ADDENDUM NO. ONE
FERNDALÉ PUBLIC SCHOOLS
2017 SINKING FUND PROJECTS
SUMMER 2019 RENOVATION PROJECTS
Page 1 of 2 (write up only)

February 8, 2019

ADDENDUM NO. ONE to the plans and specifications for the FERNDALÉ PUBLIC SCHOOLS, 2017 SINKING FUND PROJECTS, SUMMER 2019 RENOVATION PROJECTS, Ferndale, MI, Architect's Project No. 181794, dated February 1, 2019.

D CORRIDOR ELEVATION 'D'
 A1.0UE SCALE: 3/4" = 1'-0"

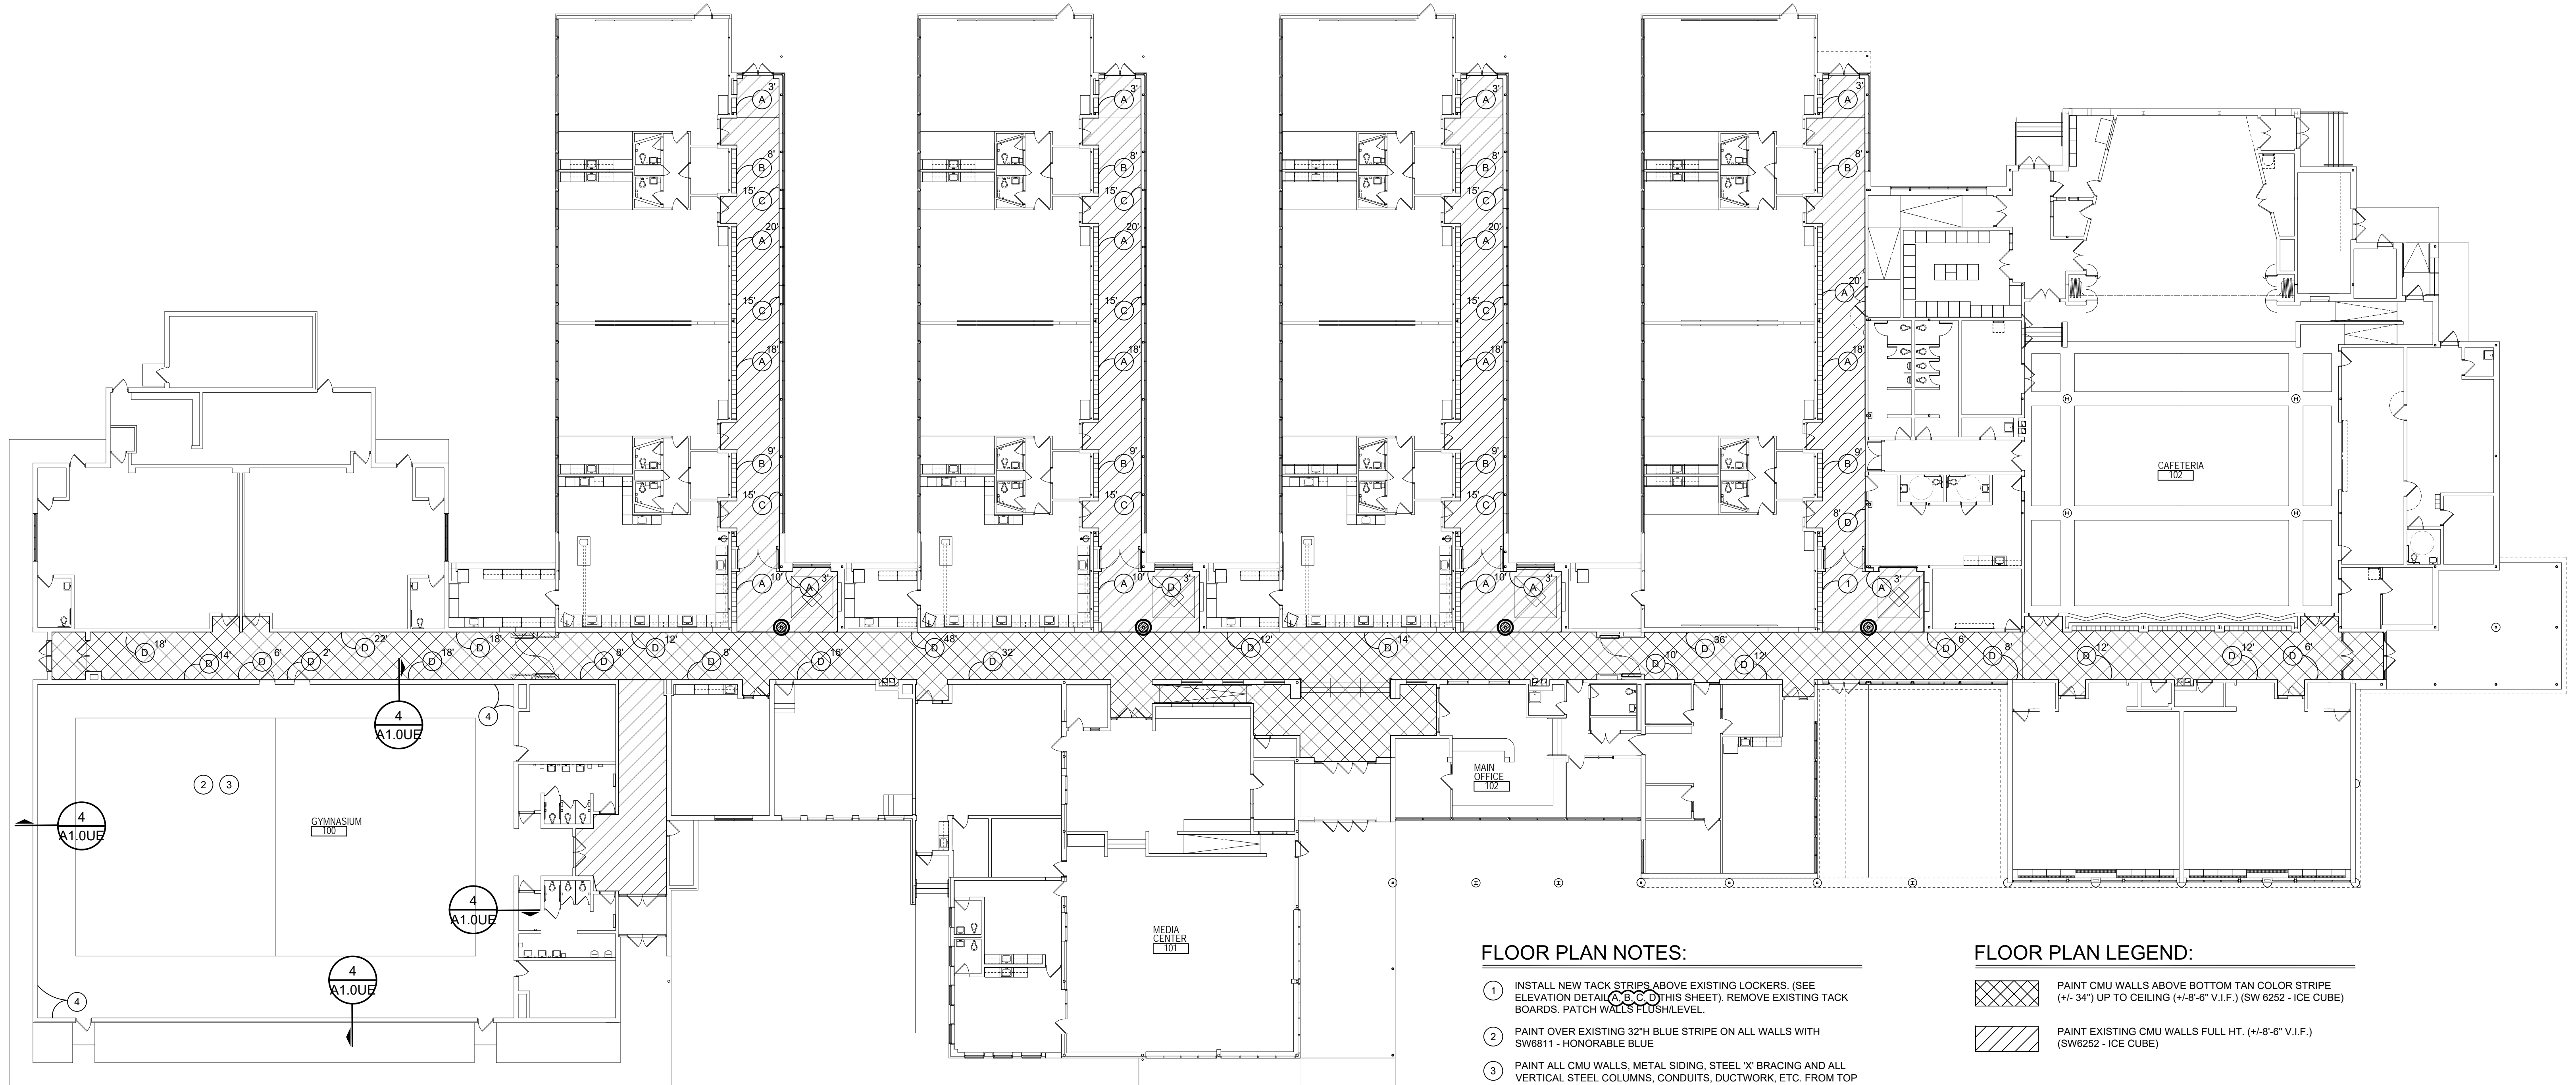
- ITEM NO. A1:** Refer to Drawing No. A1.0LE (re-issued):
- a. Refer to attached drawing no. A1.0LE for the locations of detail no. 2.
- ITEM NO. A2:** Refer to Drawing No. A1.0UE (re-issued):
- a. Refer to attached drawing no. A1.0UE for revised note no. 1.
- ITEM NO. A3:** Refer to Drawing No. A1.1UH (re-issued):
- a. Refer to attached drawing no. A1.1UH for location of typical detail no. 2.
- ITEM NO. A4:** Refer to Drawing No. A1.0H (re-issued):
- a. Refer to attached drawing no. A1.0H for revised New Work Note 29.
